PROJECT: Summerlin Village 22 - Parcels C and D

CITY OF LAS VEGAS INTER-OFFICE MEMORANDUM

Drainage Study for:

Summerlin Village 22 - Parcels C and D

FIGURE 5
ULTIMATE CONDITIONS DRAINAGE
AND STORM DRAIN MAP

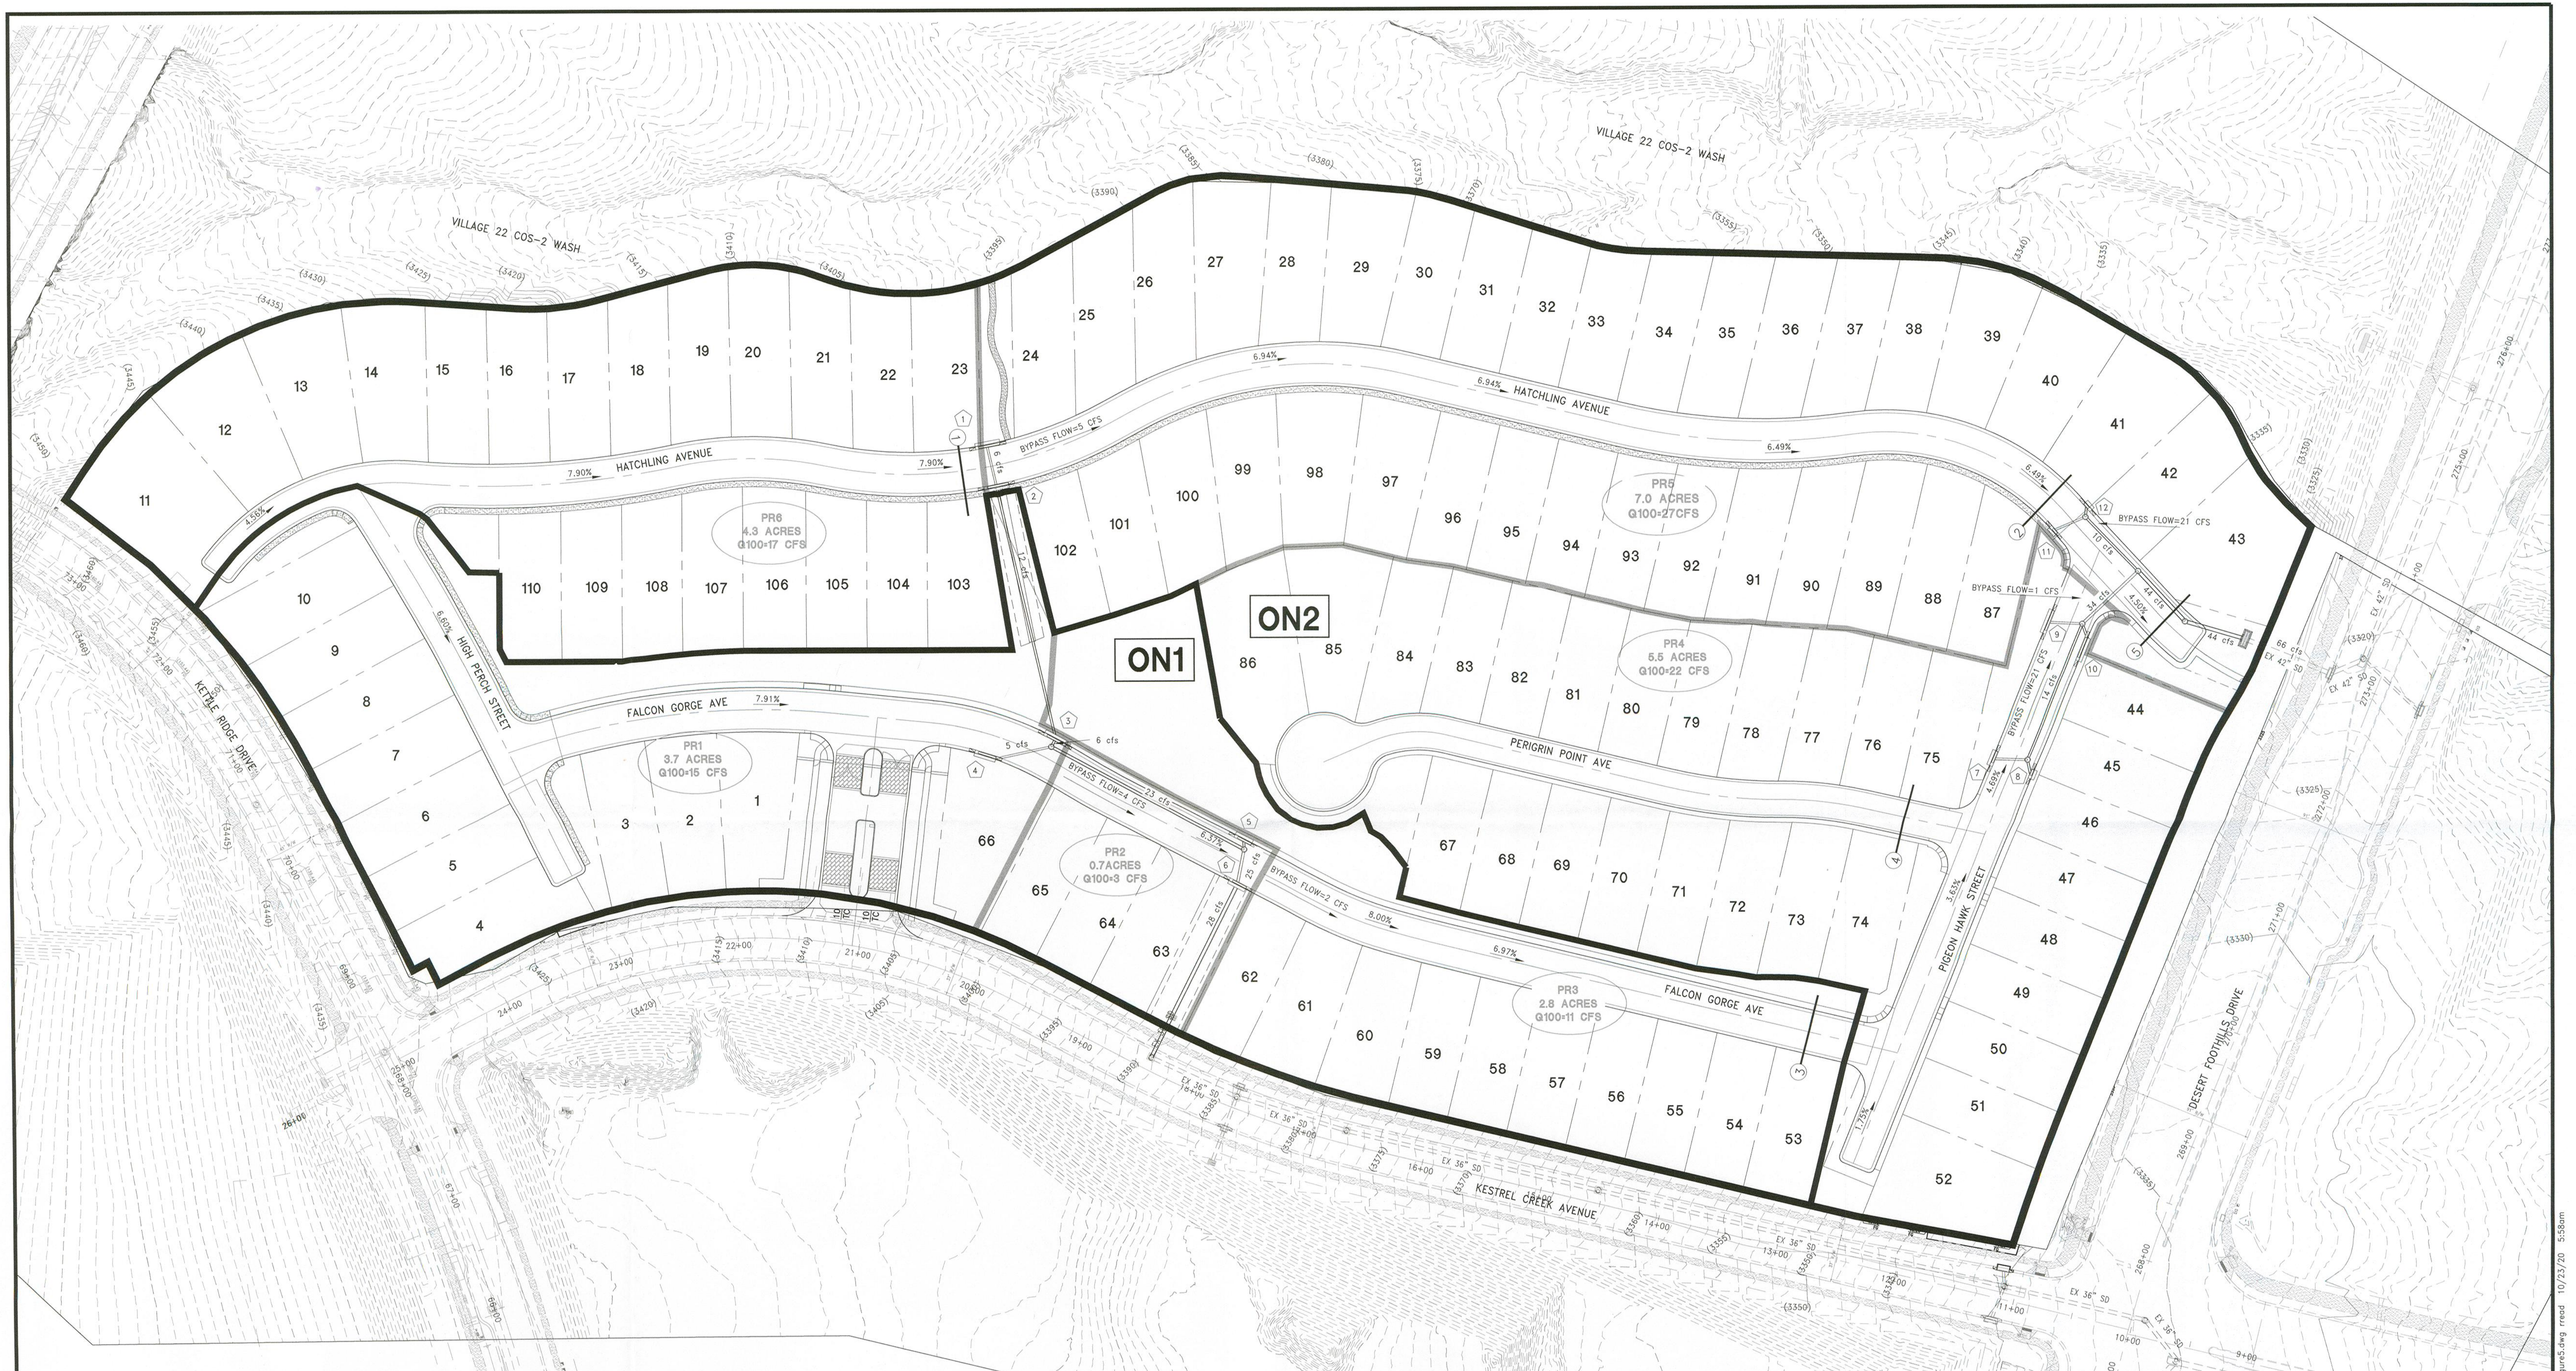
3. Show the *Flow Depth* and *Velocity* values from *Appendix C* for the adjacent streets *Kettle Ridge Drive*, *Kestrel Creek Avenue*, and *Desert Foothills Drive* on Figures 5 and 6.
